WENDY'S- ORANGE AVE PLAT

SUMMARY

PROPOSED PLAT

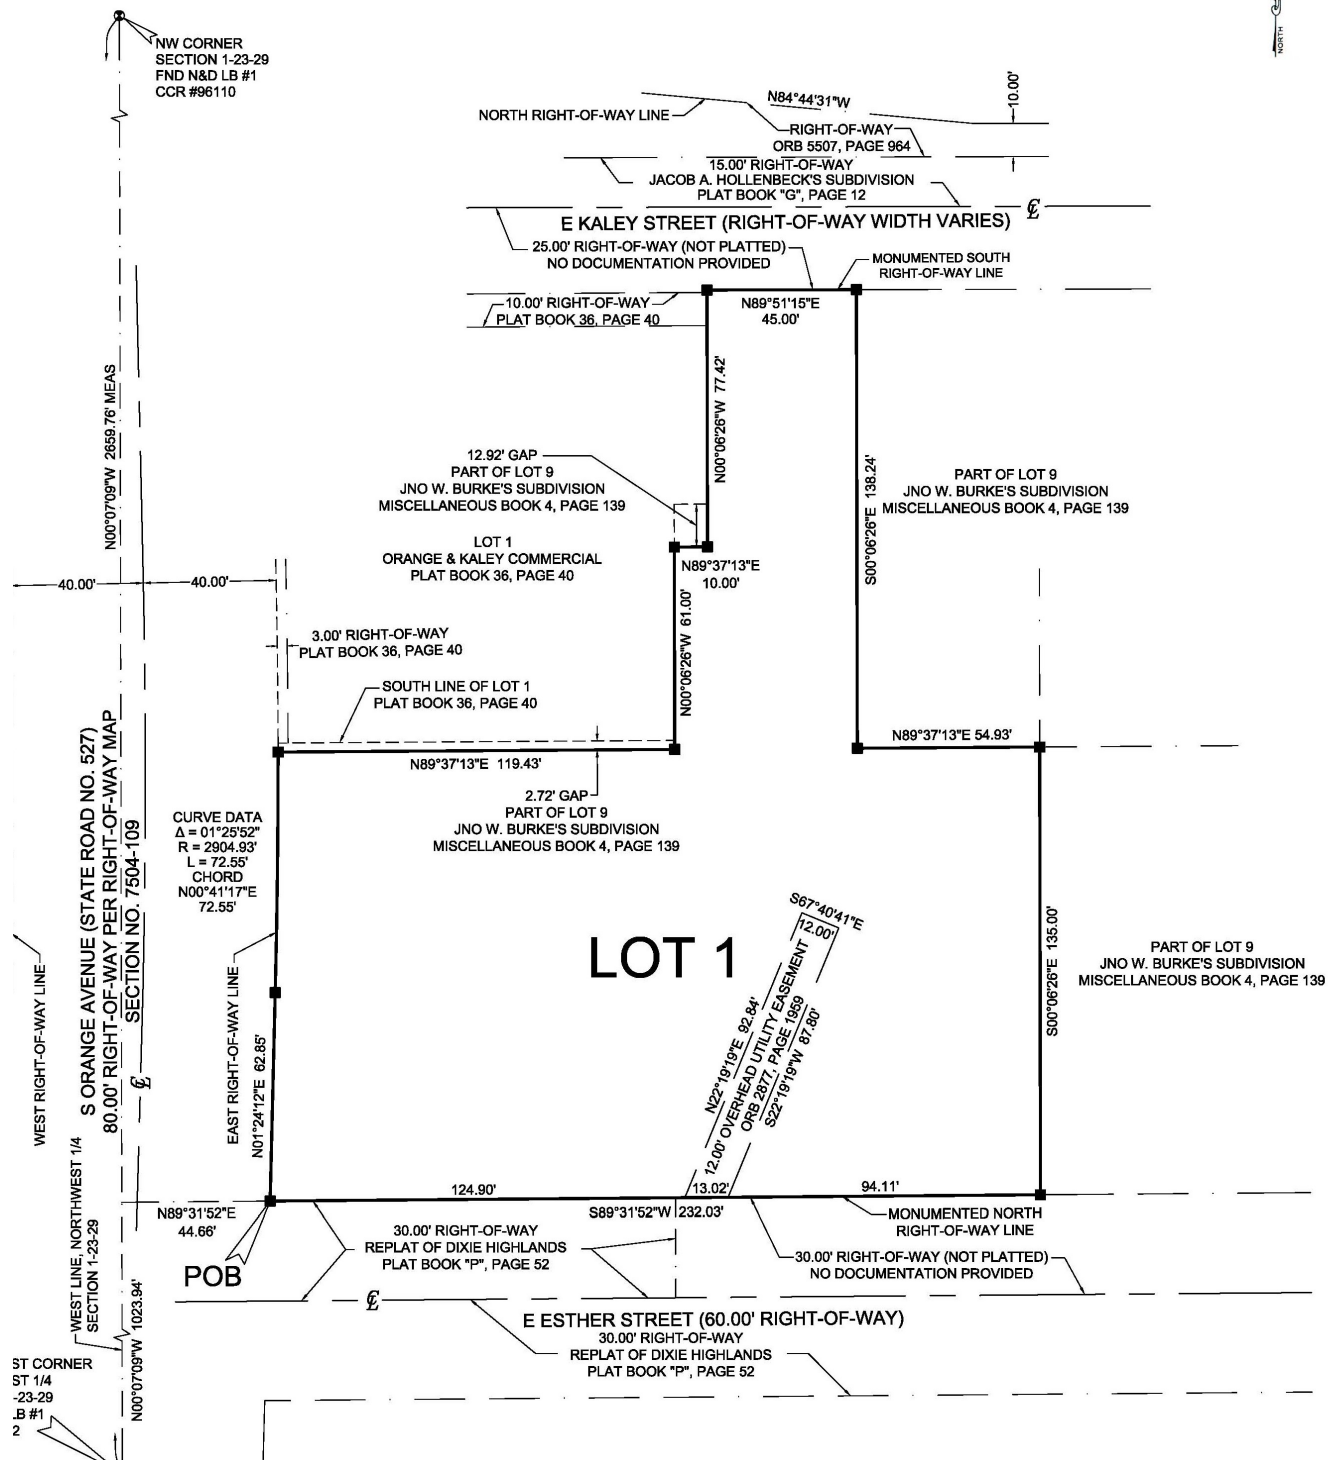
1. Easement Dedications. The Sidewalk & Utility easement on the western property line of this parcel adjacent to the Orange Av right-of-way shall be shown on this plat or accurately described in the attached notes. The cross access easement between this property and the parcel immediately northwest and adjacent shall be shown on this plot or accurately describe in the attached notes.

2. Concurrency Management. The final recorded plat shall contain the following note: "Development on the property depicted on this plat is subject to the requirements of Chapter 59, the Concurrency Management Ordinance of the City of Orlando, which governs the City's ability to issue building permits on this property. Approval of this application shall not be deemed to provide any vested rights, except as to those matters depicted hereon, that are consistent with the requirements of Chapter 177, Florida Statutes, or were required by the City of Orlando as a condition of platting."
